Saco Planning Board
Meeting Minutes
October 2, 2018
City Hall Conference Room, 1st Floor, 6:00 PM

Saco Planning Board
Meeting Minutes
October 16, 2018
City Hall Auditorium, 2nd Floor, 5:30 PM

PROJECT: RICKER ROAD SUBDIVISION RICKER ROAD, SACO, MAINE	DATE: 9/14/2018
SHEET TITLE: OVERALL WATERSHED MAP	SCALE: 1" = 200'
PREPARED FOR: SEBAGO LAND DEVELOPERS, INC 144 DRYAD WOODS ROAD RAYMOND, MAINE 04071	DESIGNED: MTW
	JOB NO.: 1722
	FILE:
	SHEET C-6.0

PROJECT:	RICKER ROAD SUBDIVISION
SHEET TITLE:	SITE LAYOUT PLAN
PREPARED FOR:	SEBAGO LAND DEVELOPERS, INC
DATE:	9/14/2018
SCALE:	1"=50'
DESIGNED:	MTW
JOB NO.:	1722
FILE:	1722-S
SHEET	C-2.0

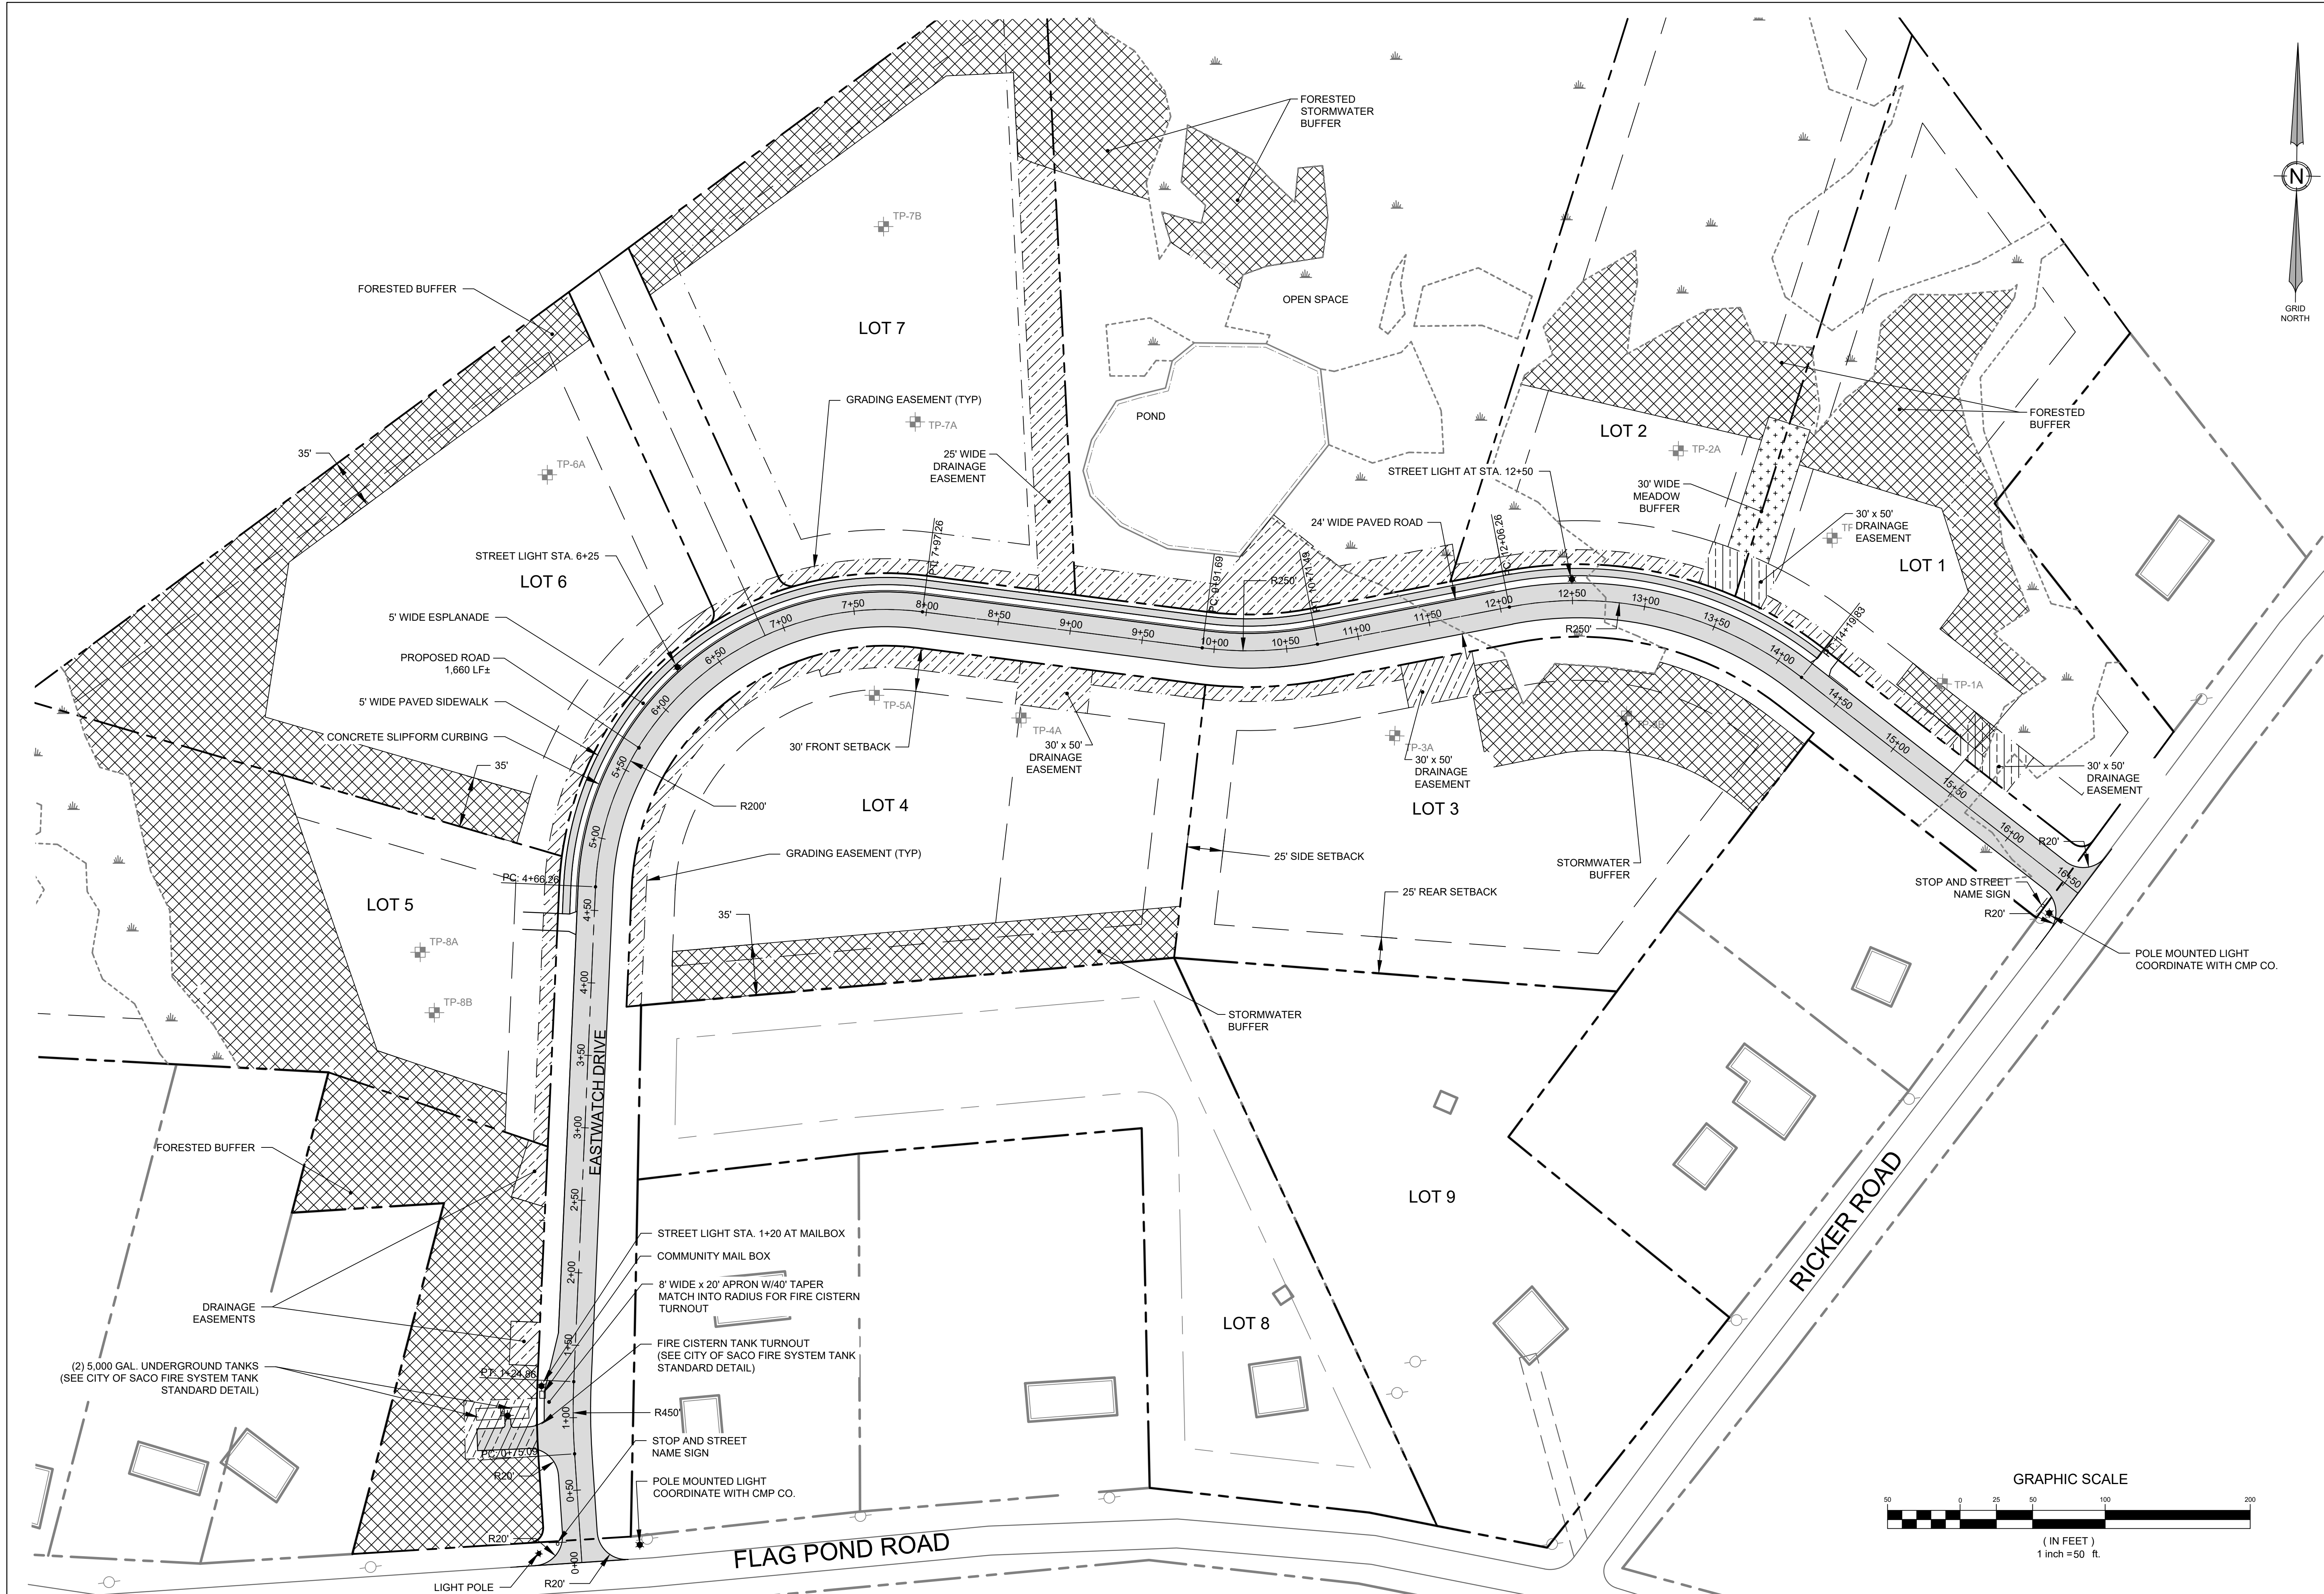
- **Police Department** – Typically the City would seek a new streetlight at both the intersection created by the new street, if one does not already exist, and at the end of the dead-end. Deputy Chief Huntress has suggested streetlights on each curve as well as both intersections. Those lights are shown on sheet C 2.0.

Street lights are now shown on Sheet C-2.0 at the locations noted.

TYPICAL ROAD SECTION
NOT TO SCALE

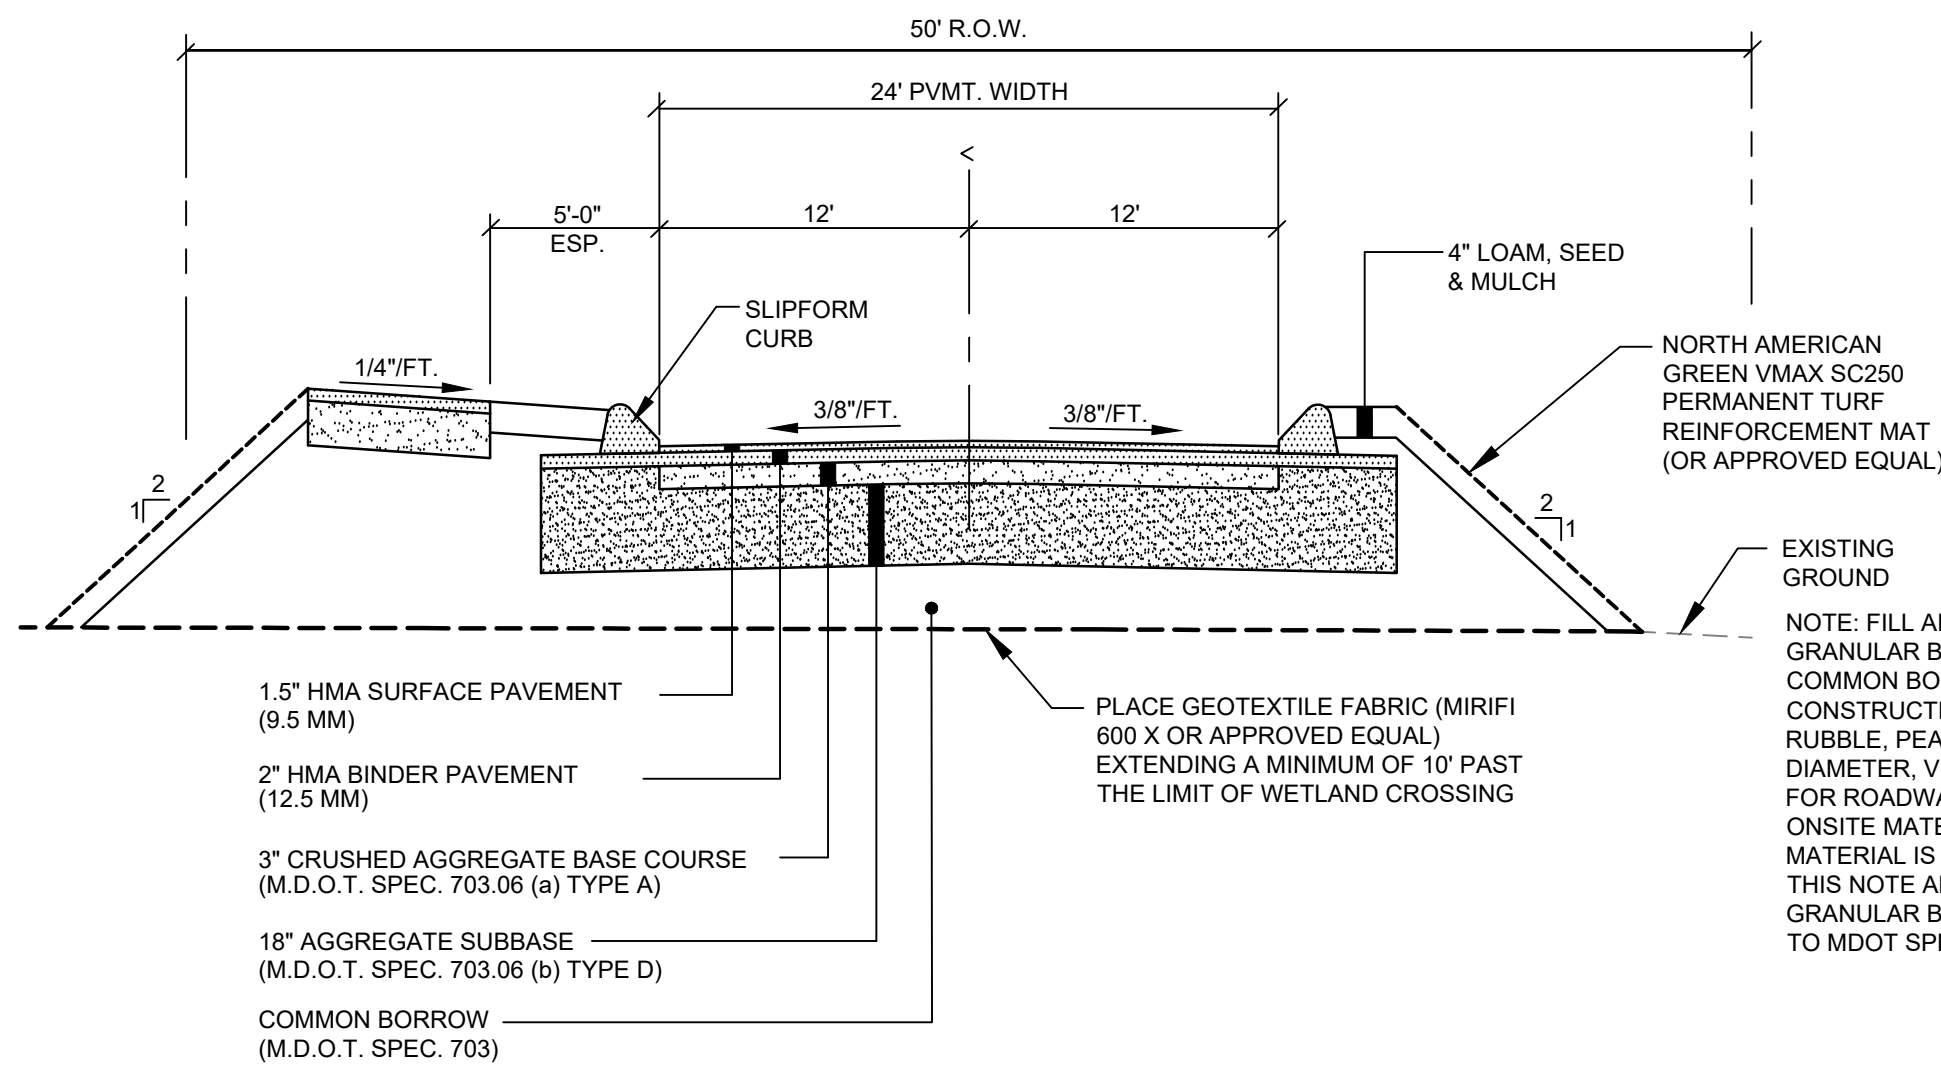
The depth of the roadside ditches shall be designed to provide 2' of cover over the top of all driveway culverts. The typical roadway sections should specify the minimum roadside ditch depth to achieve these cover requirements.

Light detail has been revised to city standards and is shown
Driveway culvert sizing requirements are shown
Road section notes ditch depth at driveway culvert locations
Wetland impacts will be flagged prior to construction and monitored not to exceed limits of fill.
Wells will not be located in the wetland areas.
No blasting ledge is planned.
